doc.: IEEE 802.15-10-0521-01-0007

**Project: IEEE P802.15 Working Group for Wireless Personal Area Networks (WPANs)**

**Submission Title:** comment and resolution about CID 59 and etc.

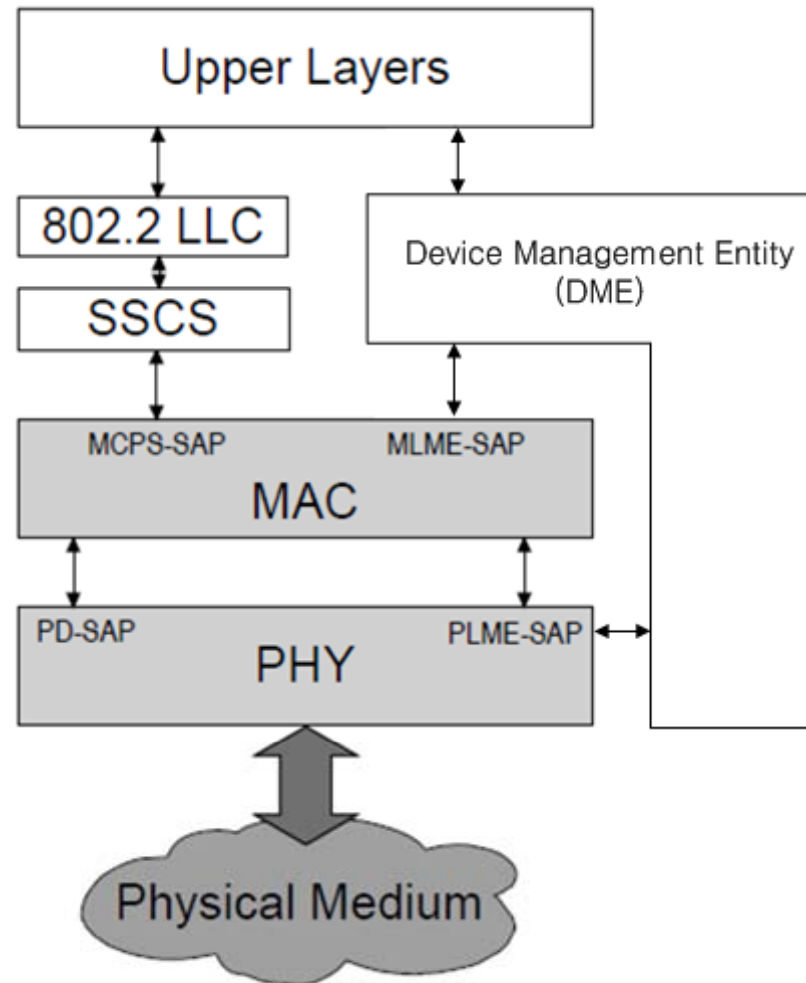
- DME is missing from Figure 3

- Modify figure 3 to include DME

- My suggestion is **Accept**.
- Instruction to editor: insert DME in figure 3. please refer next slide.
